# 1ST & PIKE

103 PIKE STREET

EARLY DESIGN GUIDANCE 2  
06 FEBRUARY 2018  
DPD #3028428

3. ROOF AMENITY

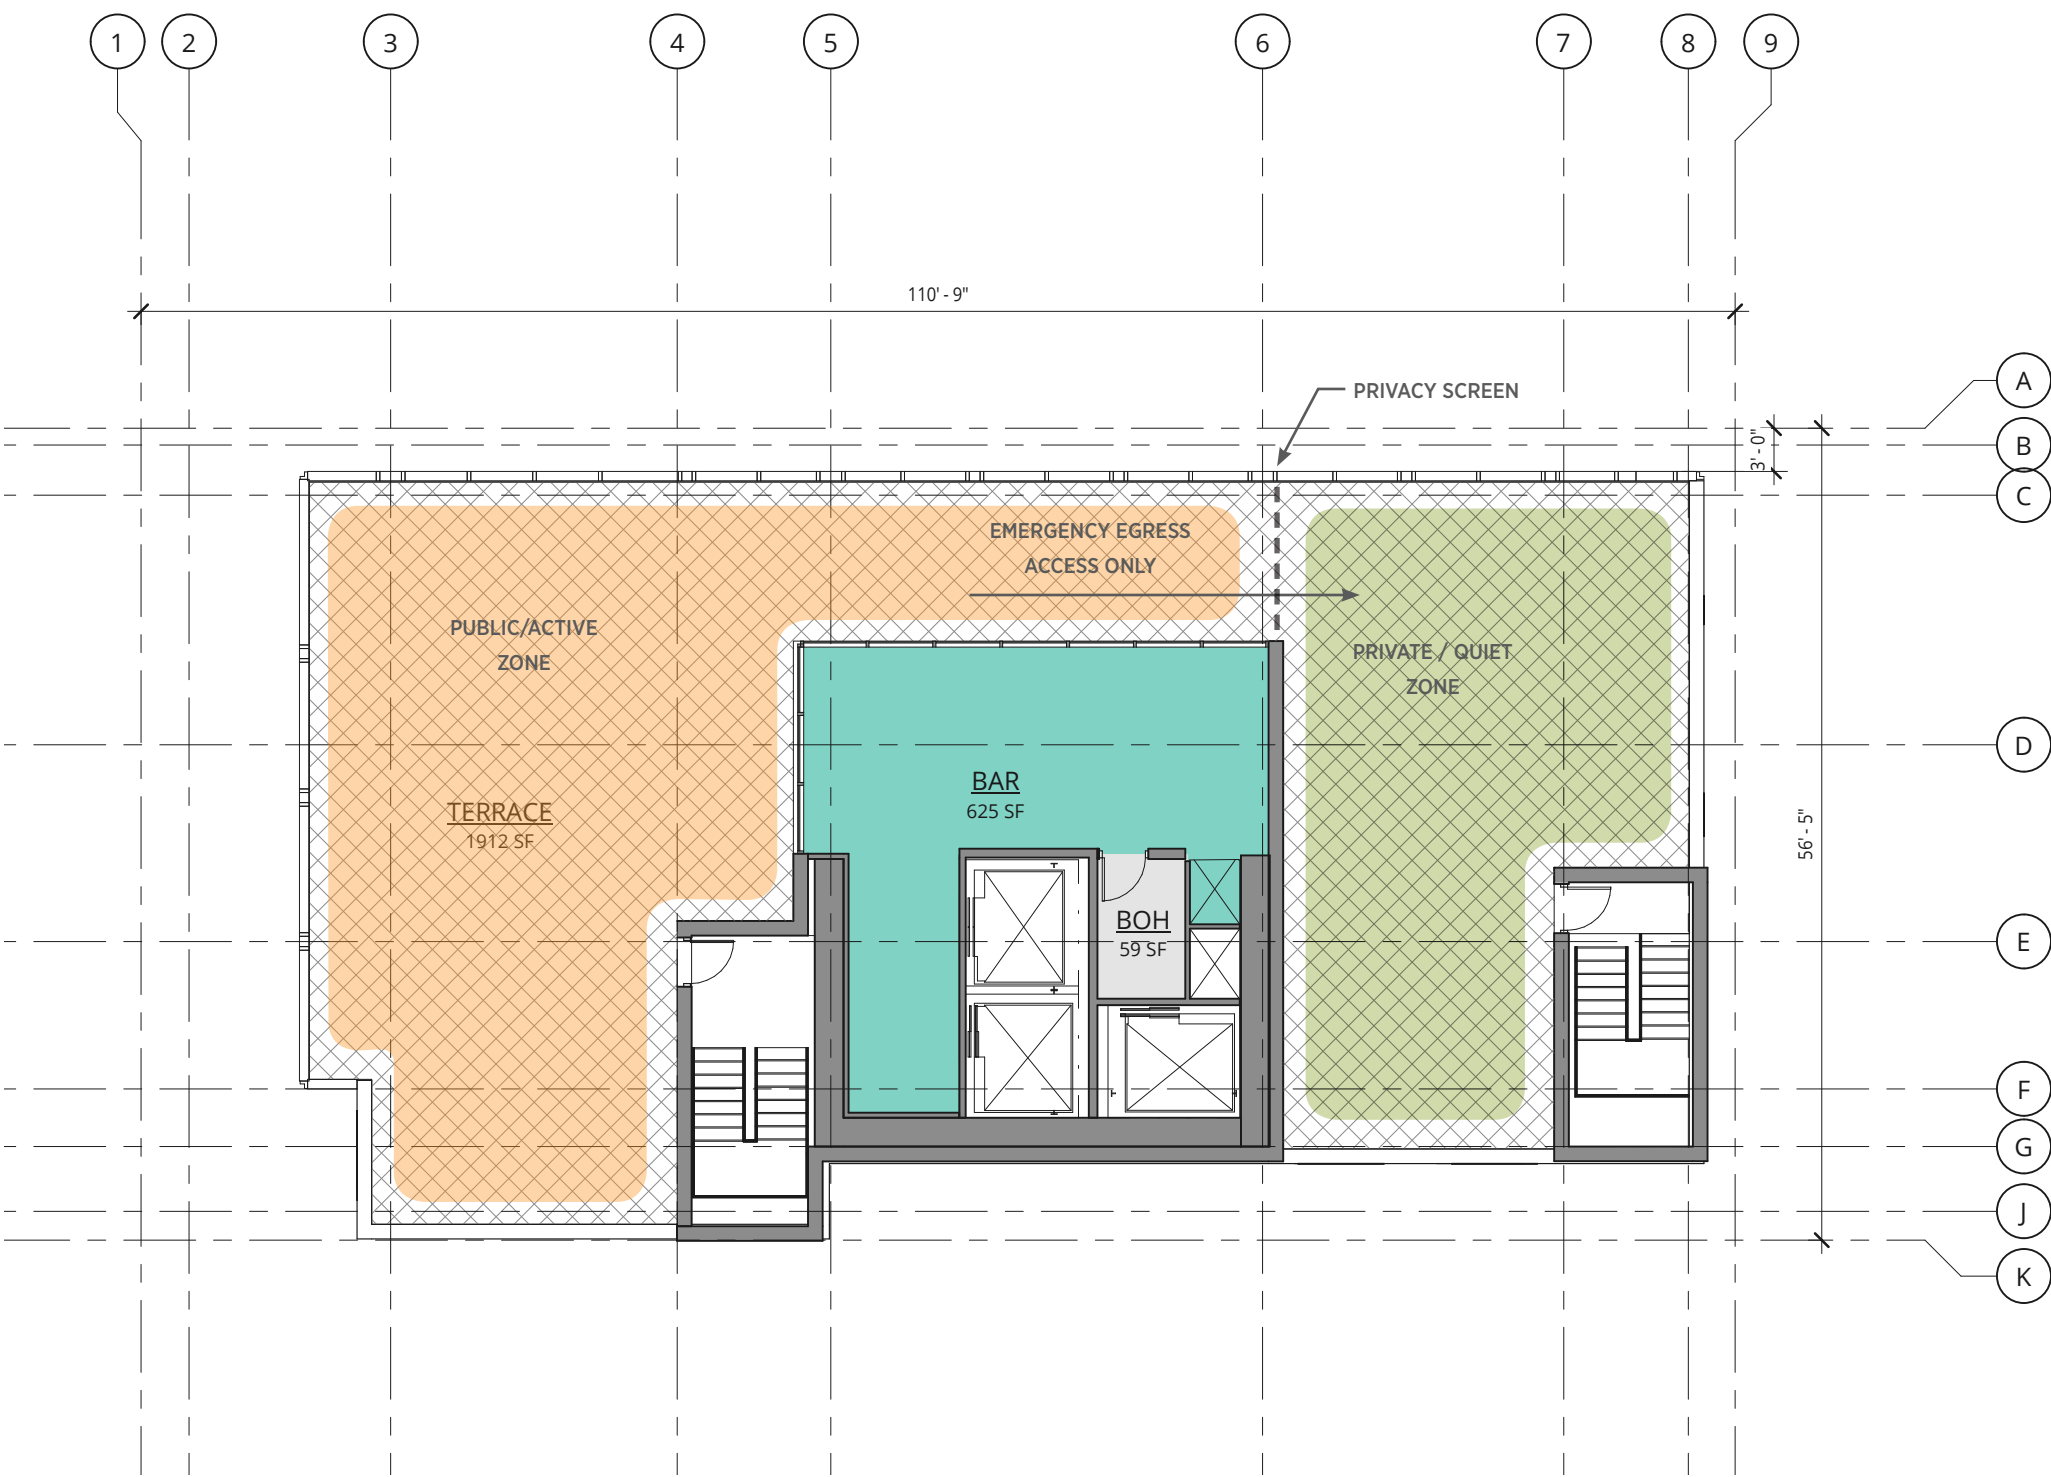
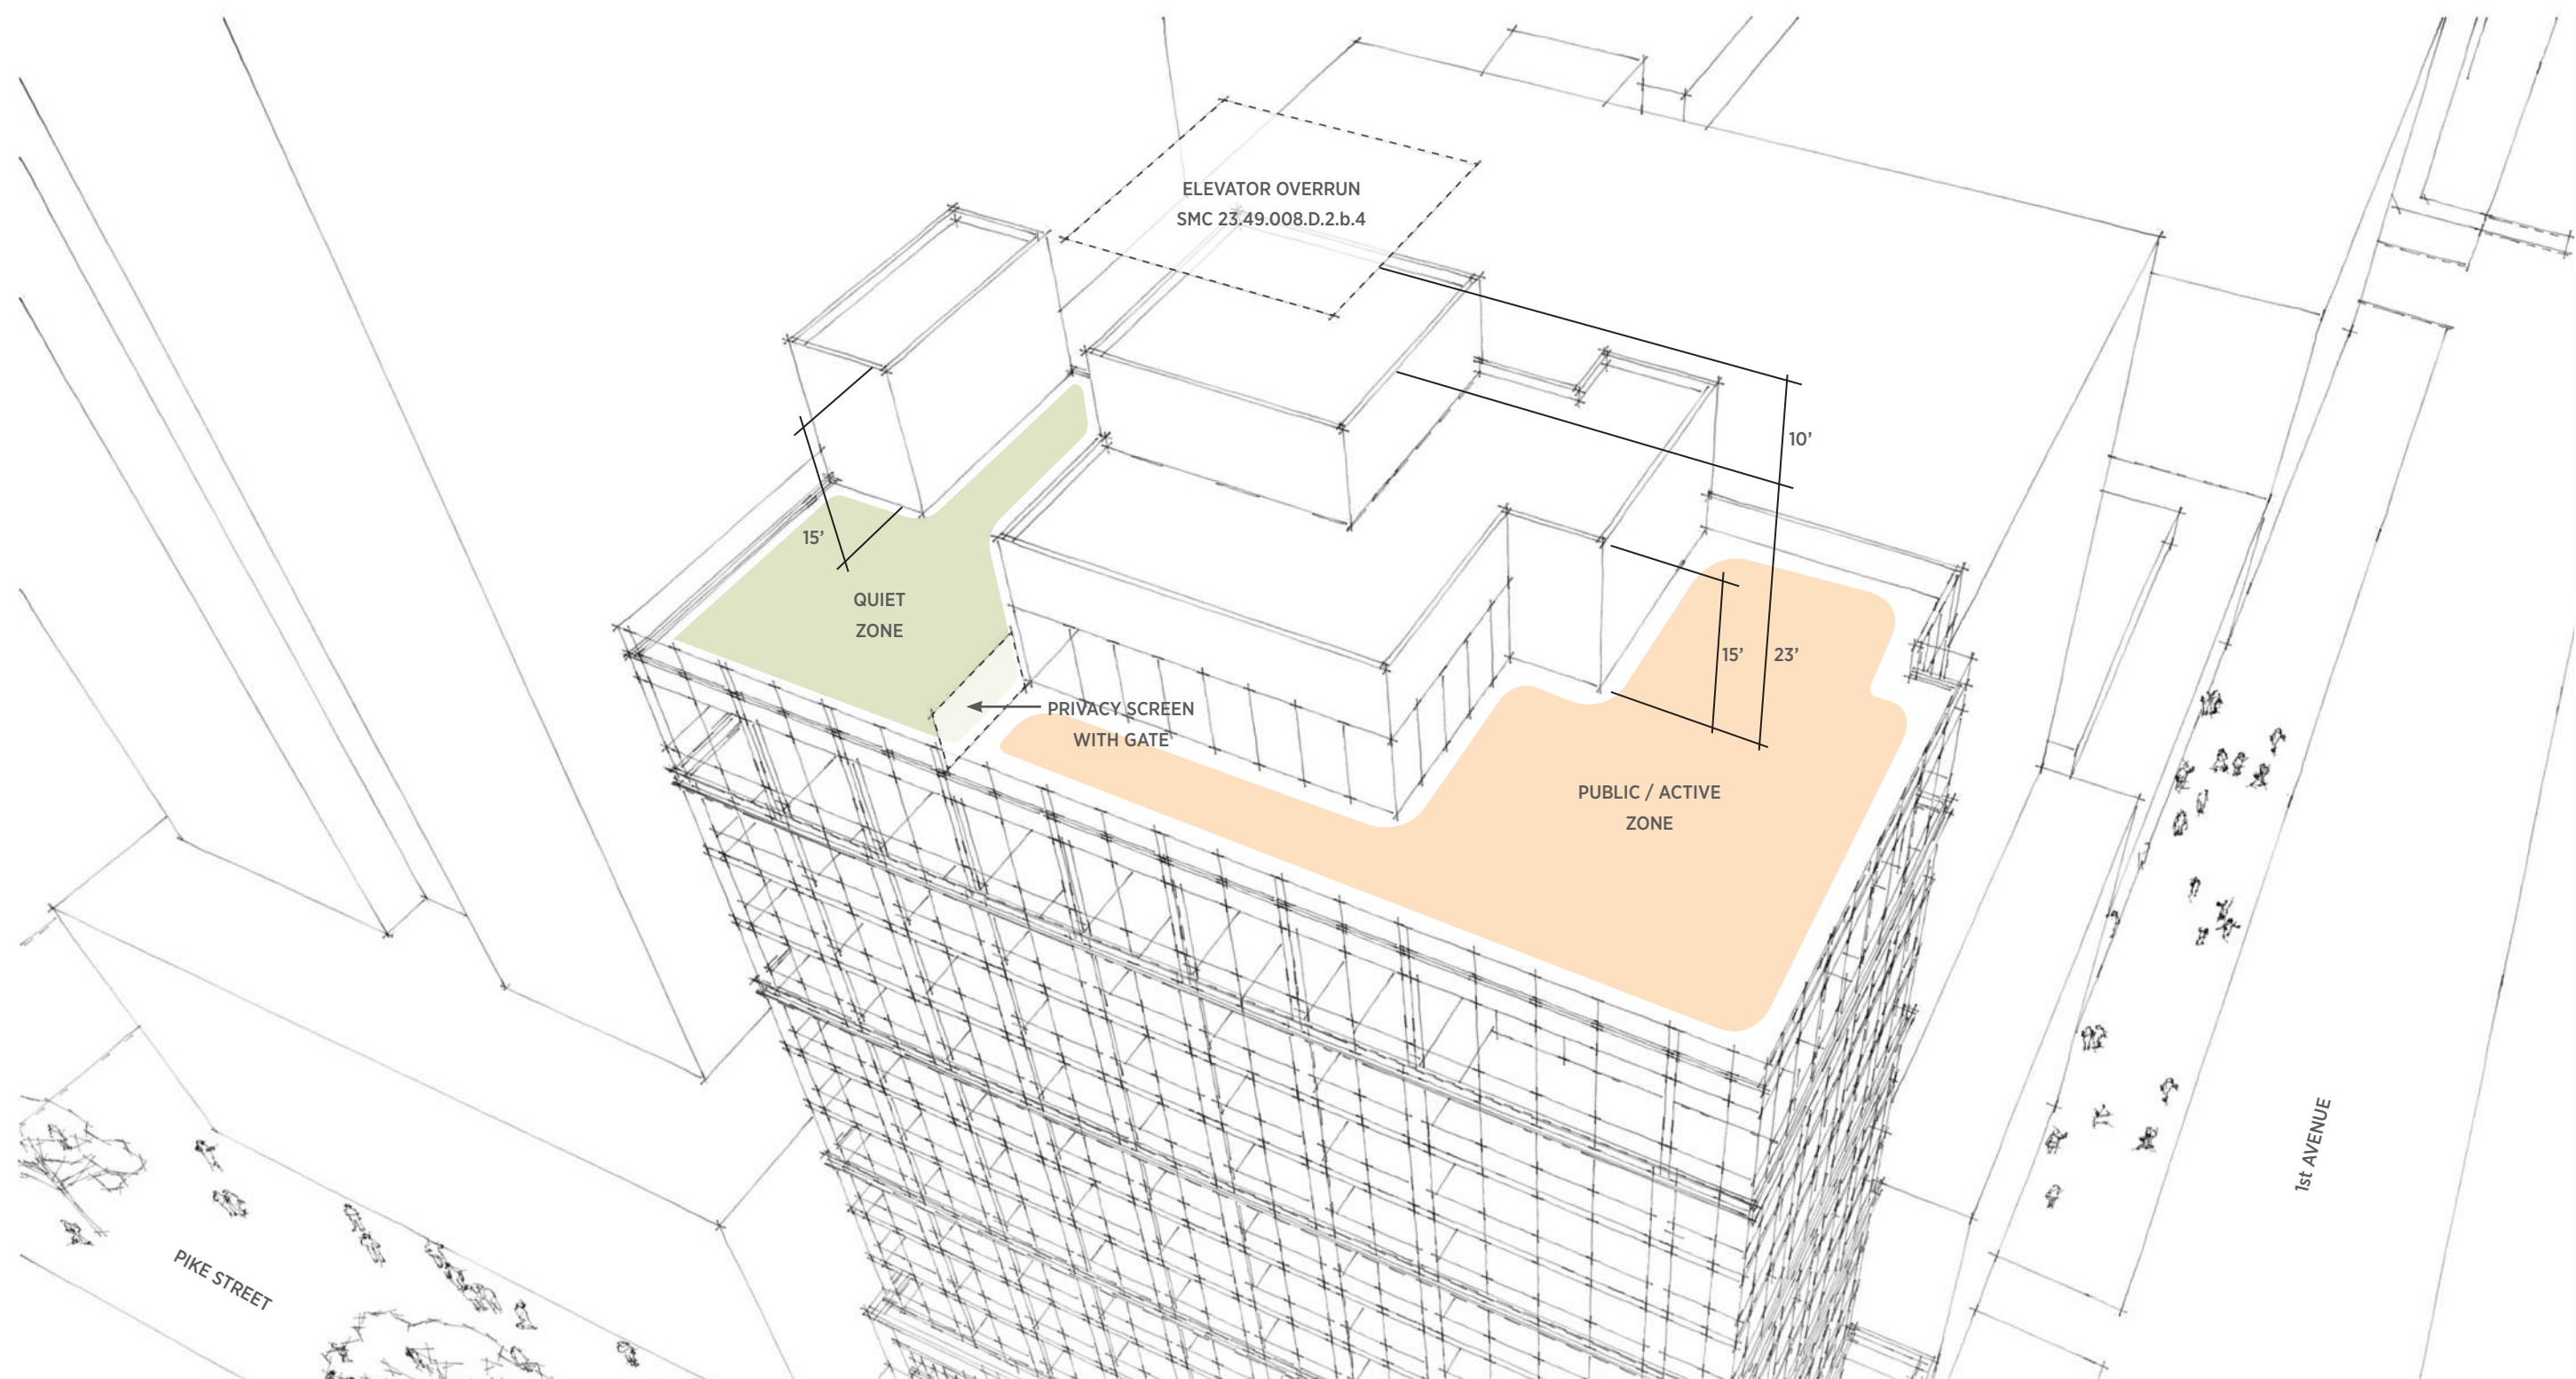
The Board stated that the roof-level amenity area, inclusive of elevator overruns and rooftop equipment, should be a coherent composition and designed/considered as the 5th Facade due to it's visibility to neighboring developments. The Board reviewed the preliminary roof terrace design illustrated in the design packet and supported the direction in which the conceptual design is headed. The Board requested to review design details (landscaping, hard-scape , screening etc.) at the Recommendation meeting that further clarify the roof terrace's appearance and programing.

The rooftop features include the elevator and stair overruns as well as a rooftop bar open to the public. The rooftop amenity has been designed to ensure privacy for the neighboring condo building. The outdoor area is divided by the overrun and bar into two distinct zones: active and quiet.
